ADDENDUM No. 1
TOWN CENTER DOG PARK FENCE PROJECT

CITY OF OREGON
DEPARTMENT OF PUBLIC SERVICE

TOWN CENTER DOG PARK
FENCE SITE PLAN

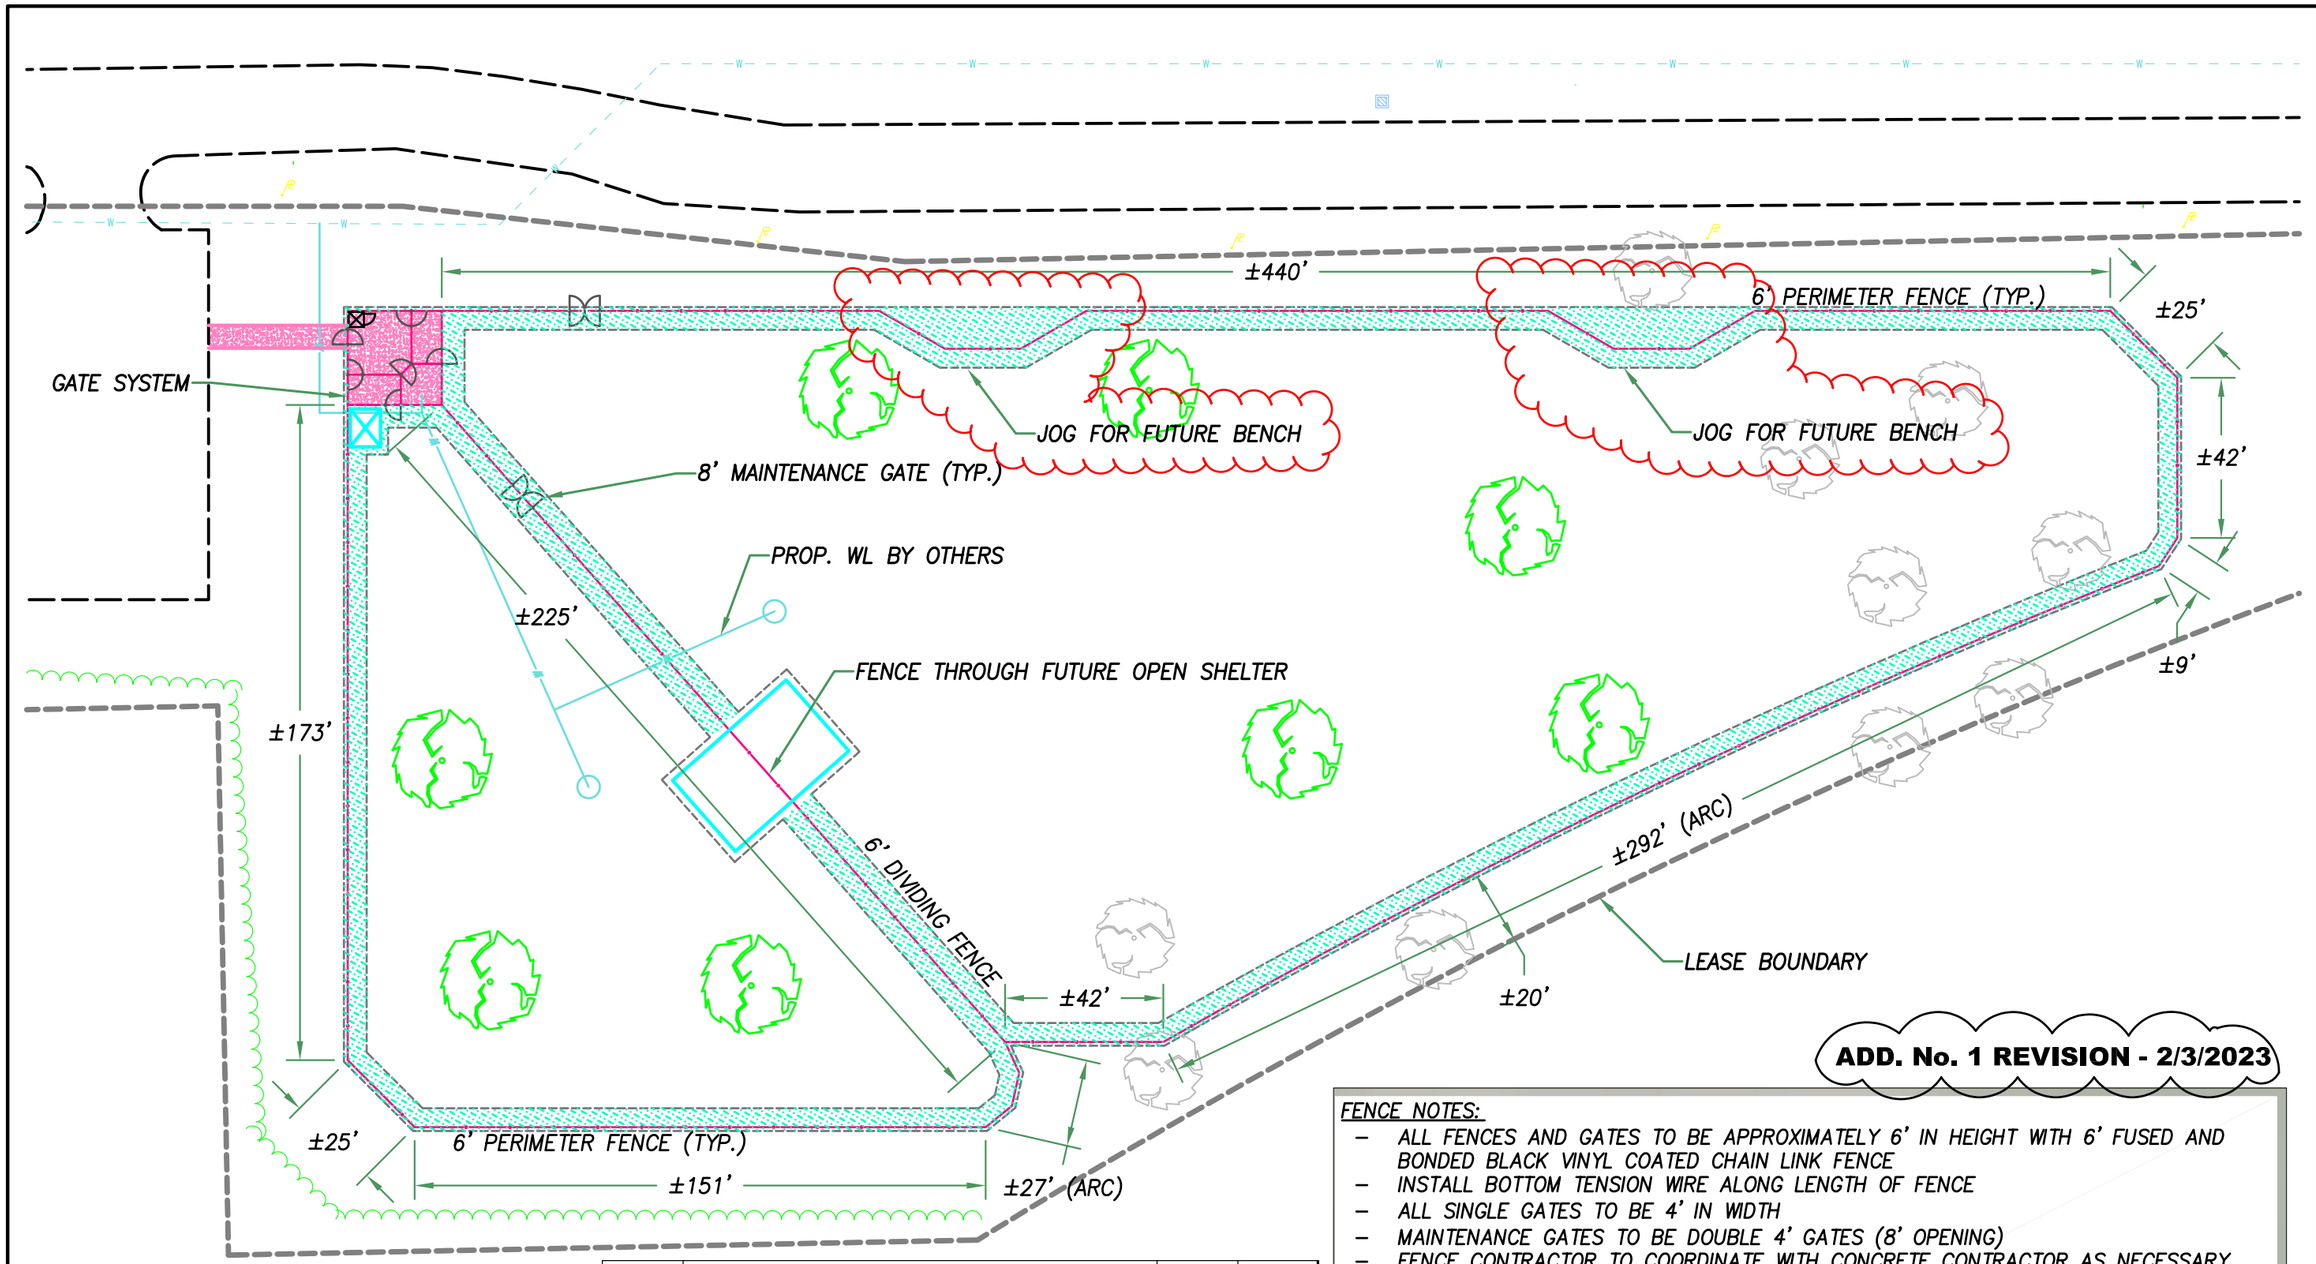
Replace PLAN SHEETS 1, 2, AND 3 in the Plan Set with the attached **REVISED PLAN SHEETS 1, 2, AND 3 – DATED 2/1/2023** that references revised fence post sizes, clarified fabric gauge, and added two jogs in easternmost fence line. Quantity of fence has been adjusted for these jogs and to allow for the placement of exterior fence post to be just outside the concrete pad at the entrance.

ADD. No. 1 REVISION - 2/3/2023

POST ENCASEMENT DETAIL

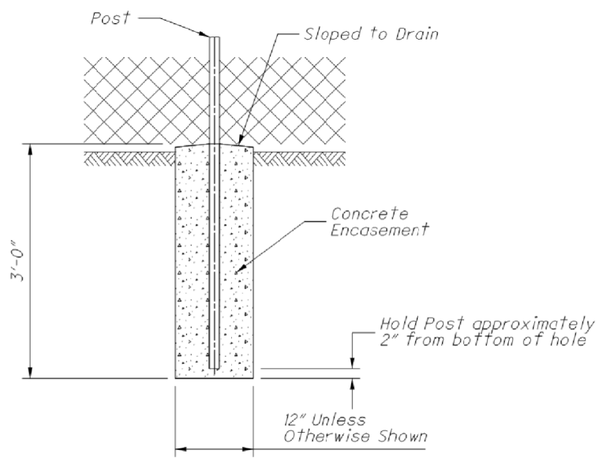
Question #2 – Can you confirm the requirements for the post installation regarding whether concrete will be required?

Plans and specifications have been revised to clarify these requirements. All end, corner, gate and terminal post shall be embedded in concrete per the Post Encasement Detail on sheet 3 of the project plans. Line post may be driven to an embedment depth of 48" per Line Post Detail on sheet 3 of the plans or embedded in concrete and installed per the Post Encasement Detail.

ALL END, CORNER, GATE AND TERMINAL POSTS SHALL BE ENCASED IN CONCRETE.
